Response to Action Item 3-81 Section 3.7.2

SEB Issue List Regarding for APR1400 DCD Section 3.7.2 (Including Associated Technical Reports)

Figure 1. Connections between RCS Support and Solid Element

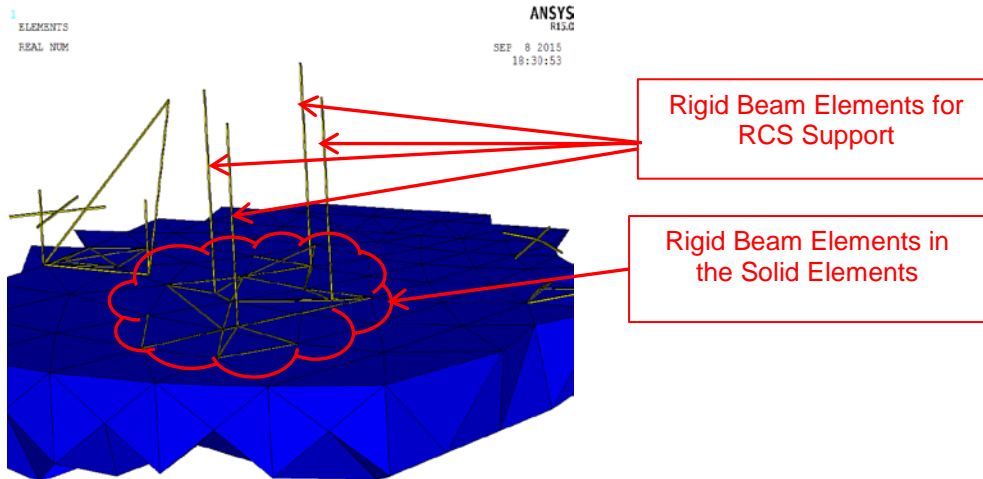
APR1400-E-S-NR-14002-P should clarify how the degree of freedom compatibility is addressed for transitions between beam and solid elements (e.g. RCS supported by the PWS and SSW).

The compatibility condition between the beam elements of the reactor coolant system (RCS) and solid elements of the primary shield wall (PSW) and the secondary shield wall (SSW) was satisfied by using the rigid beam elements at the beam-to-wall support points covering the footprint of the RCS support brackets. RCS supports are modeled as rigid beam elements and connected with other rigid beam elements in the solid elements which represent the PSW and the SSW.

Figure 1 shows the connections between RCS supports (rigid beam) and building model (solid elements). A description of the beam-to-solid element connections will be incorporated in technical report APR1400-E-S-NR-14002-P.

The compatibility condition between the beam elements of the RCS and solid elements of the PSW and SSW is satisfied by using the rigid beam elements at the beam-to-wall support points covering the footprint of the RCS support brackets. RCS supports are modeled as rigid beam elements and connected with other rigid beam elements in the solid elements which represent the PSW and the SSW.
